SUBJECT: NEW VEHICLE DEMONSTRATION / DELIVERY HOLD - Safety Recall 17S15
- Supplement #8
Certain 2015-2017 Transit Vehicles Equipped with a Driveshaft Flexible Coupling
Driveshaft Flexible Coupling Repair

New! REASON FOR THIS SUPPLEMENT

- **Technical Information:** *The enhanced driveshaft flexible coupling installation procedure has been updated to provide clarification on the correct orientation of the coupling. In addition, the front driveshaft section replacement instructions have been removed as all vehicles can be repaired using enhanced driveshaft flexible coupling kits.*

FIGURE 2

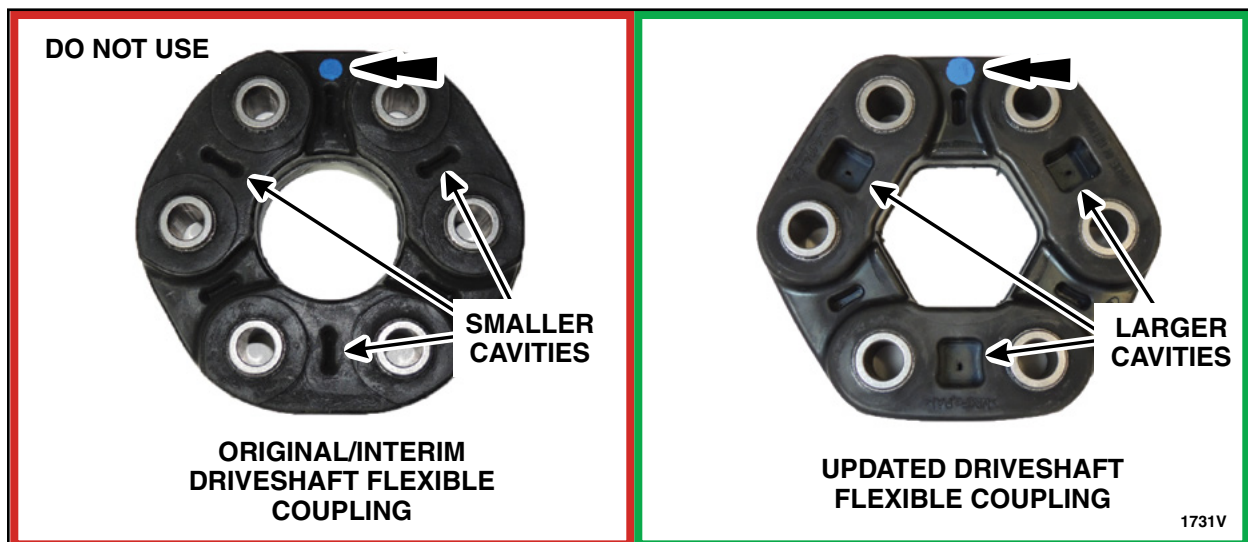
- To assist with the removal of the driveshaft flexible coupling-to-transmission output flange bolts, the use of a Mini-Ductor™ induction heating tool, or equivalent, is recommended.
- The blue paint marking on the *new* driveshaft flexible coupling must be installed facing the transmission output flange or premature failure of the flexible coupling will occur. See Figure 2.

FIGURE 10

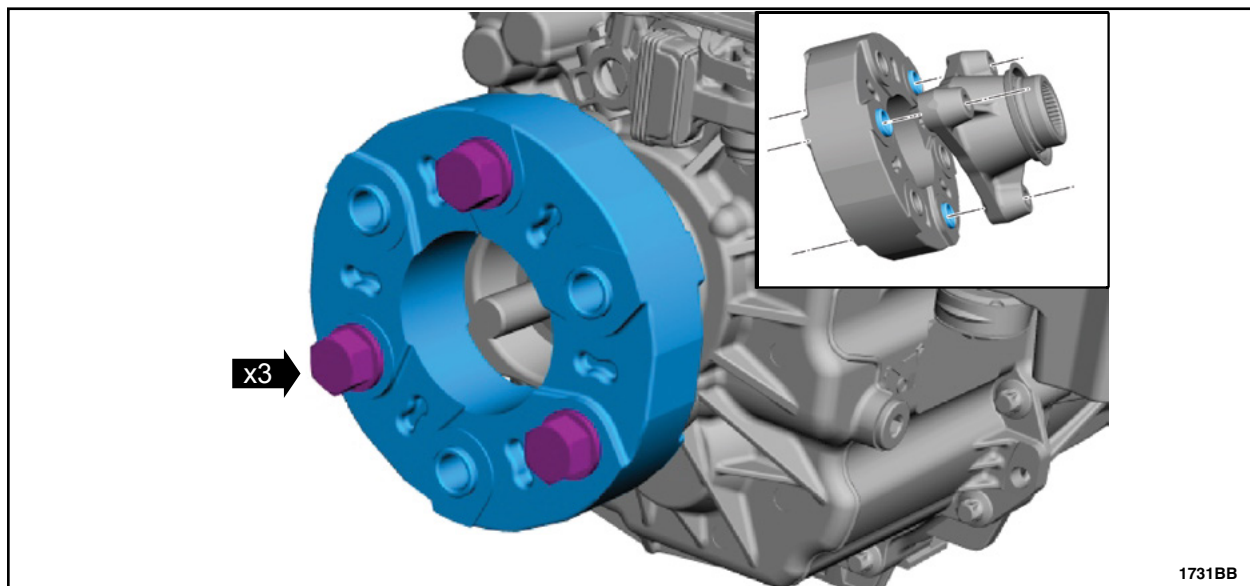
9. Install the *new* driveshaft flexible coupling. Please follow the Driveshaft Flexible Coupling Removal and Installation Workshop Manual (WSM) procedure in Section 205-01. See Figures 10 and 11.

NOTICE: The flex coupling must be installed with the blue paint mark facing the transmission output flange. The protruding flex coupling bushings must align with the driveshaft flange and transmission output flange as shown in Figures 10 and 11.

FIGURE 11

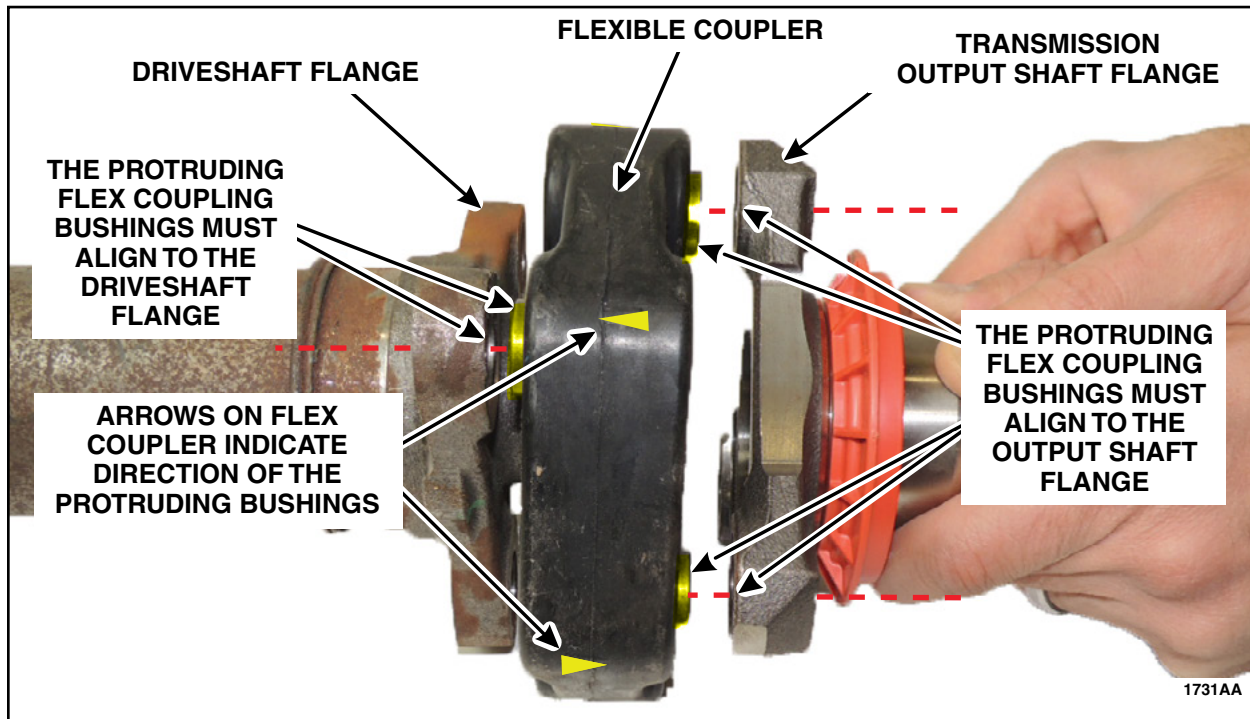
NOTE: There are six (6) bushings in the coupler. Three (3) bushings protrude forward and three (3) protrude rearward and they must interlock with each flange.

FIGURE 12

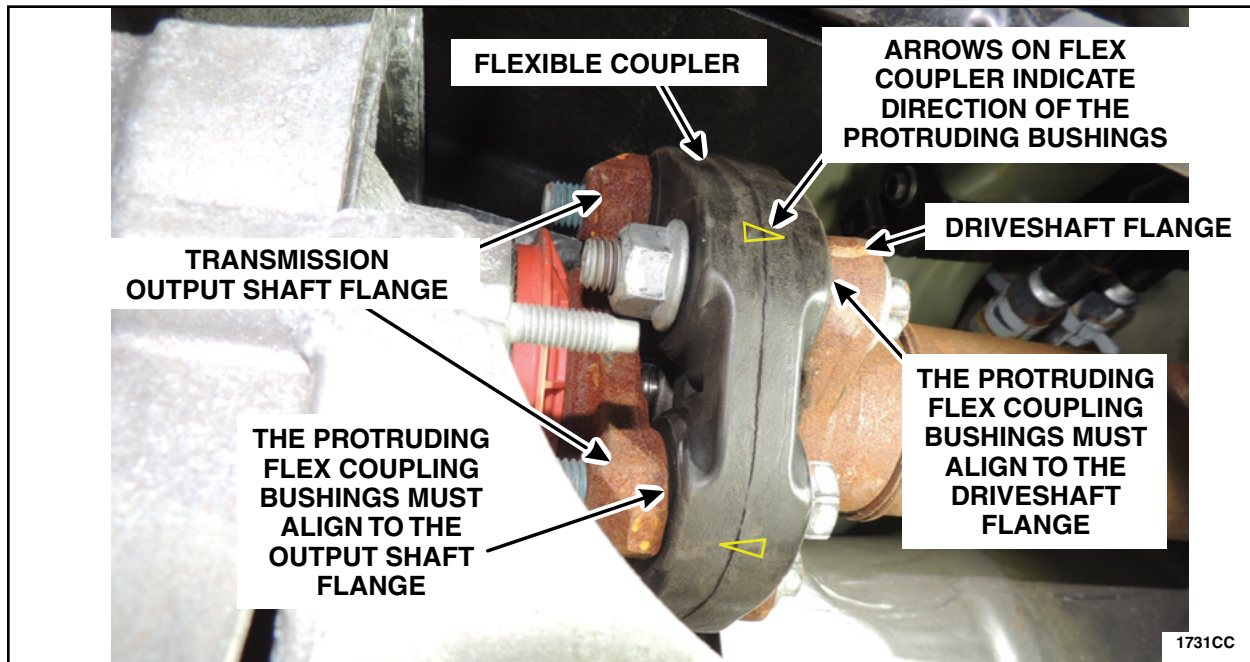
NOTICE: The flex coupler must be installed with the blue paint mark facing the transmission output flange. The protruding flex coupling bushings must align with the driveshaft flange and transmission output flange. Arrows should point at the ears of each flange shown in Figure 12.
